Block B, Former Nestle Factory

Hayes, London

Pre-Application Presentation

9TH MARCH 2023

Consented Design - GA Level B1

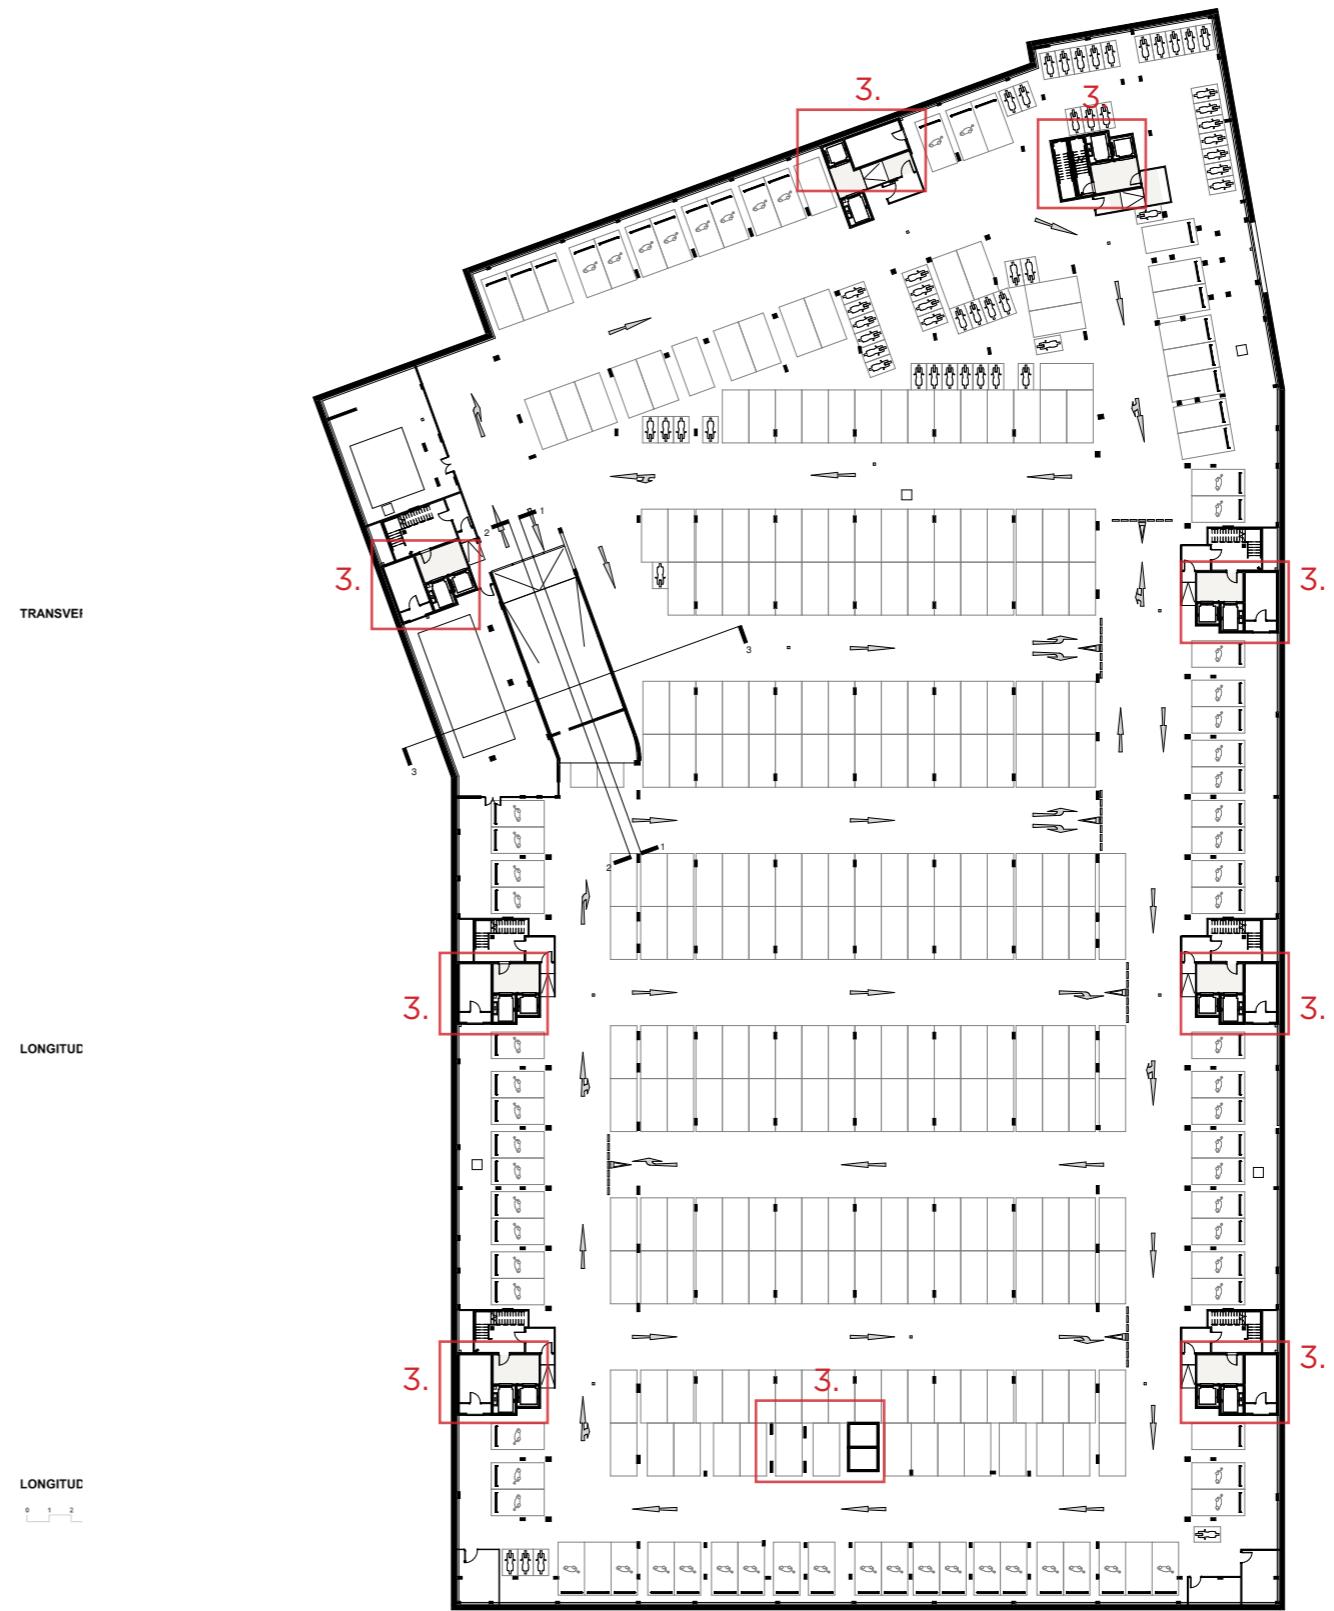
1. Omission of podium entrance canopies; security risk to adjacent apartments at first floor.
2. Addition of plant housing for car park smoke extract fans as per developed fire strategy
3. Updated core layout as per developed fire strategy; evacuation lifts added to Blocks 4 and 8
4. Reconfiguration of apartment layout. Overall mix remains as consented.

Level 00 Floor Plan

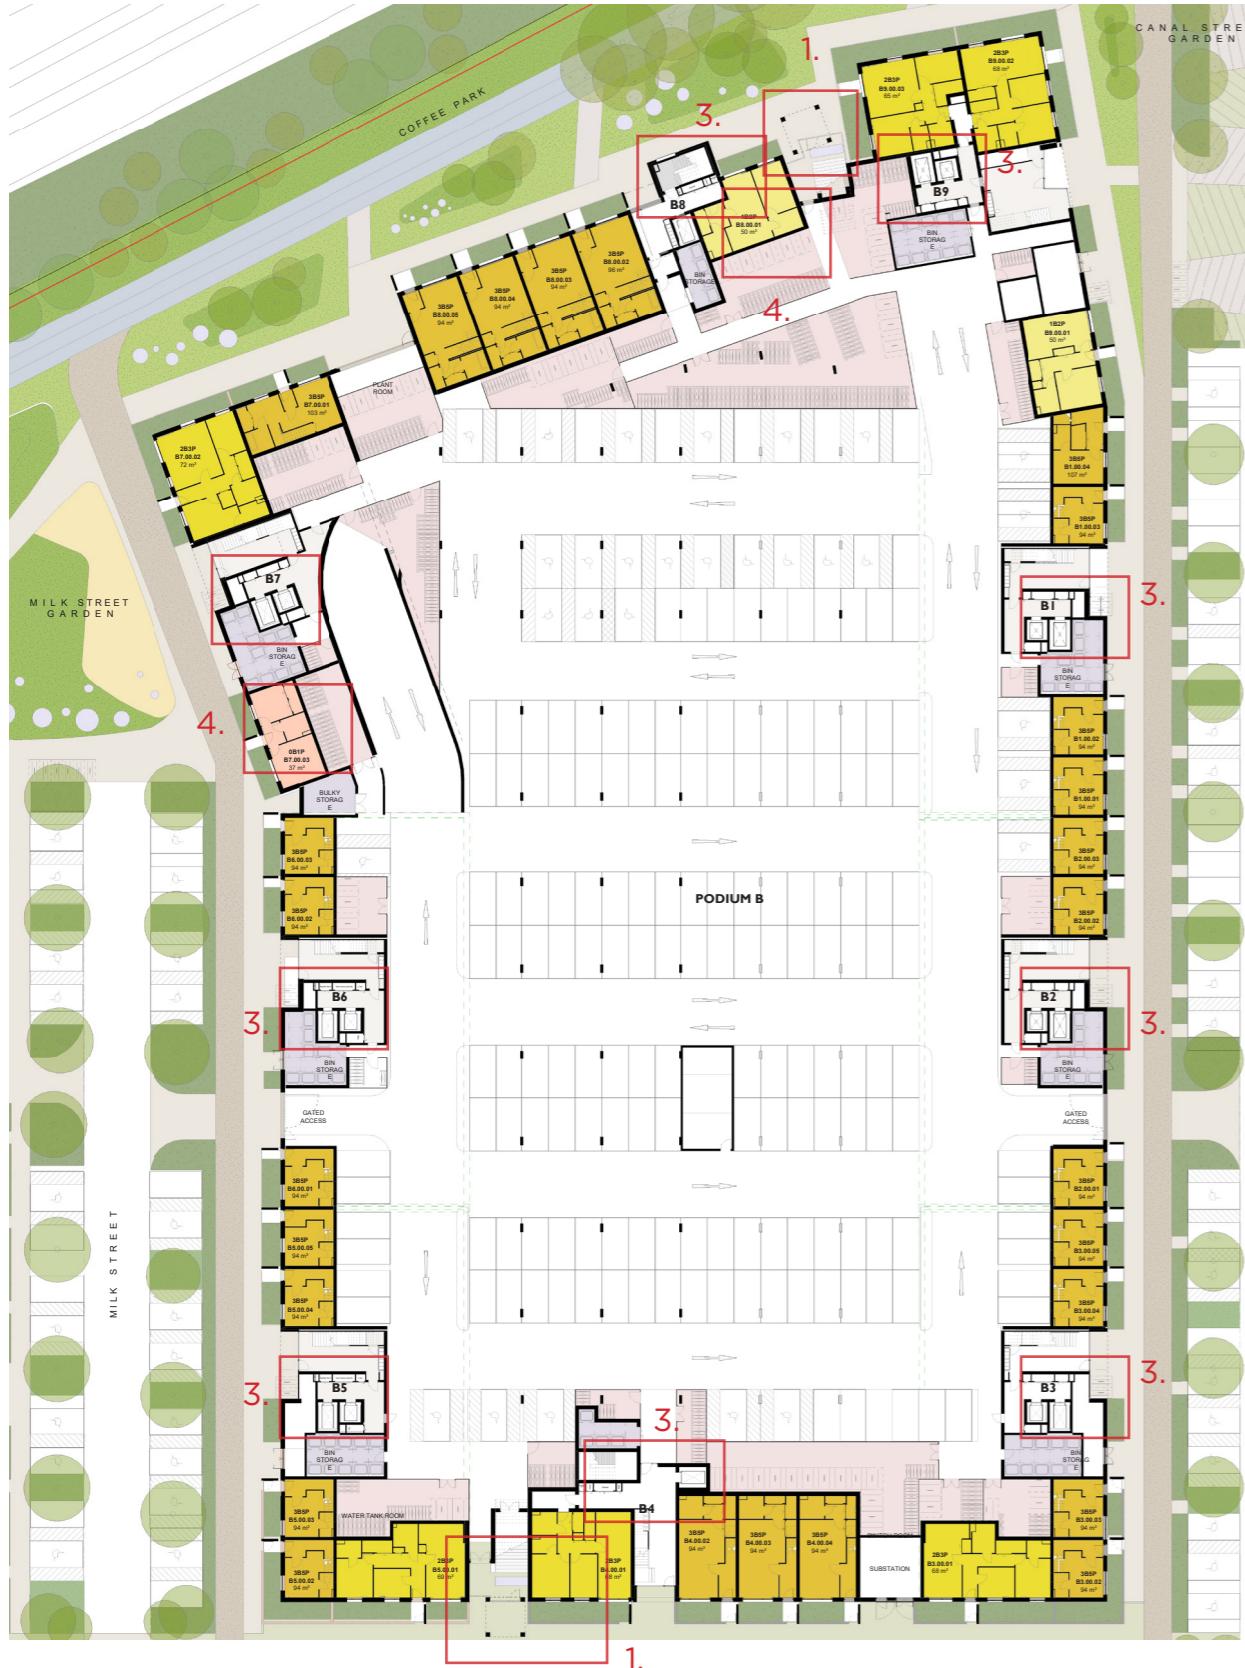
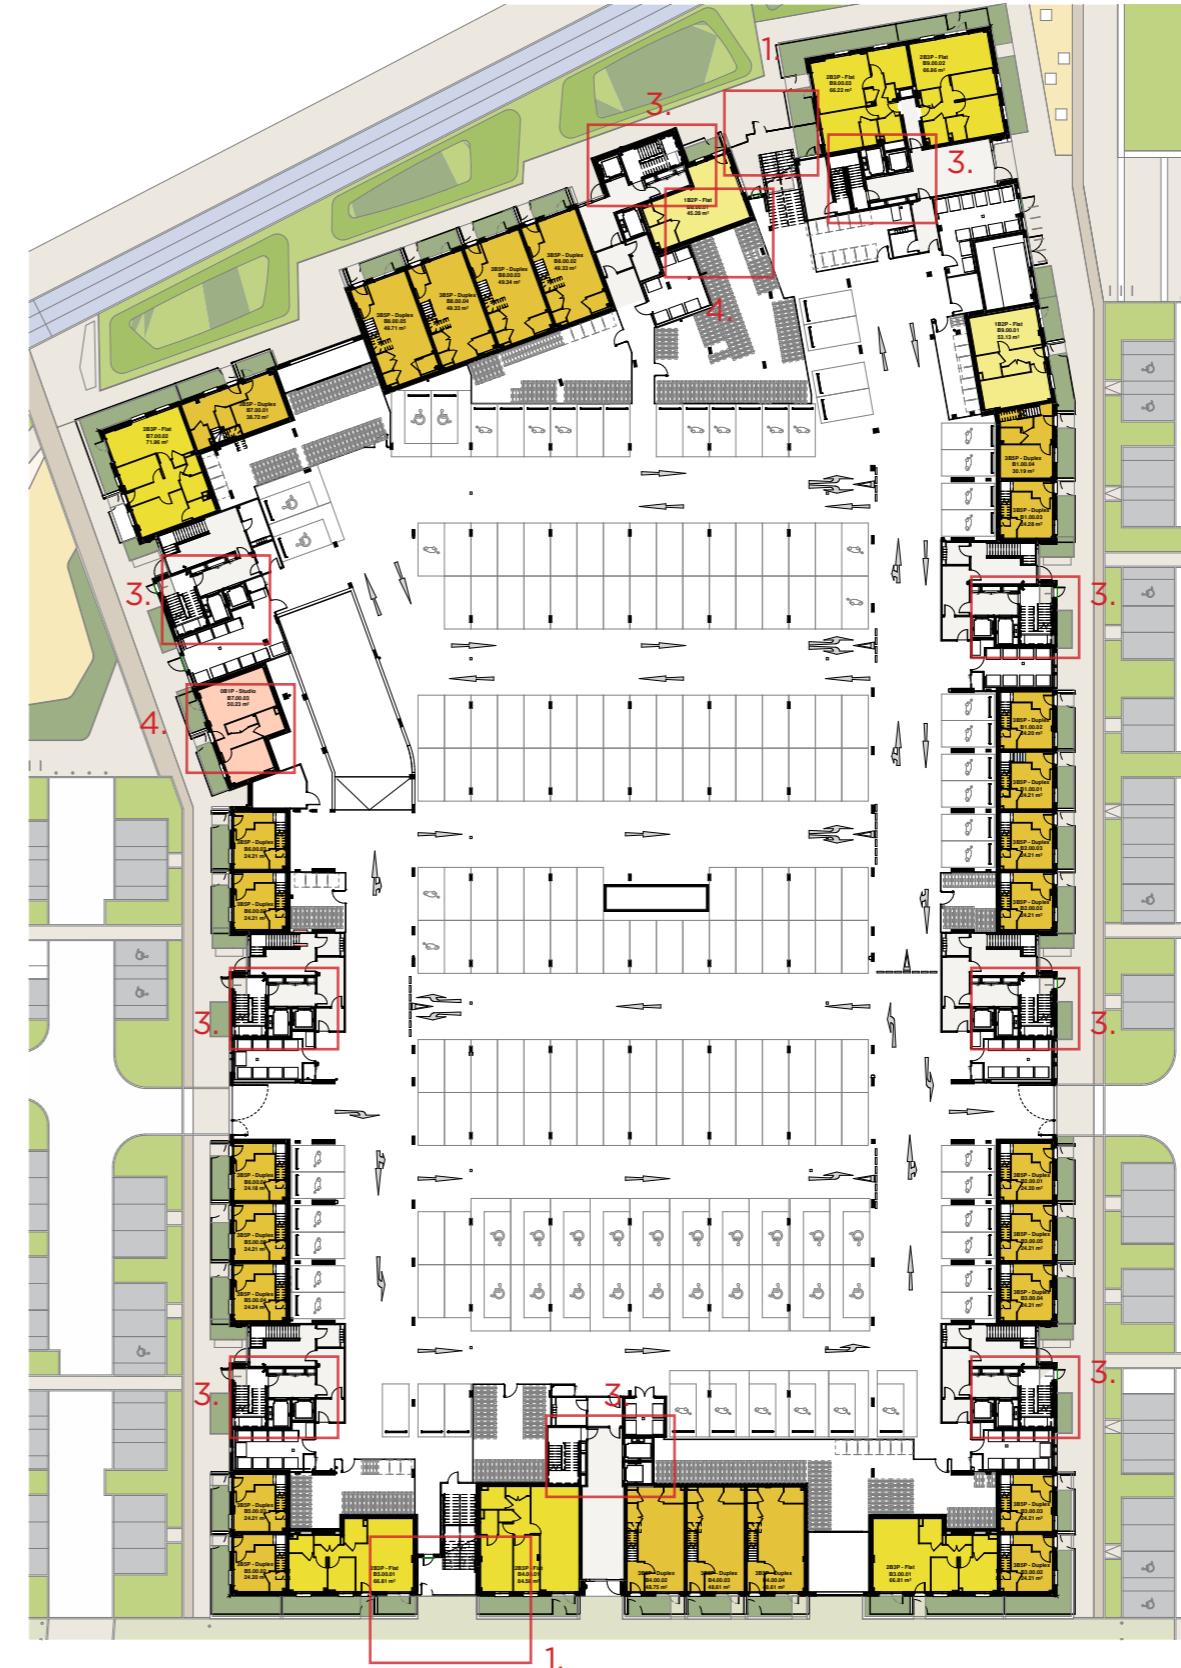
- Omission of podium entrance canopies; security risk to adjacent apartments at first floor.
- Addition of plant housing for car park smoke extract fans as per developed fire strategy

- Updated core layout as per developed fire strategy; evacuation lifts added to Blocks 4 and 8
- Reconfiguration of apartment layout. Overall mix remains as consented.
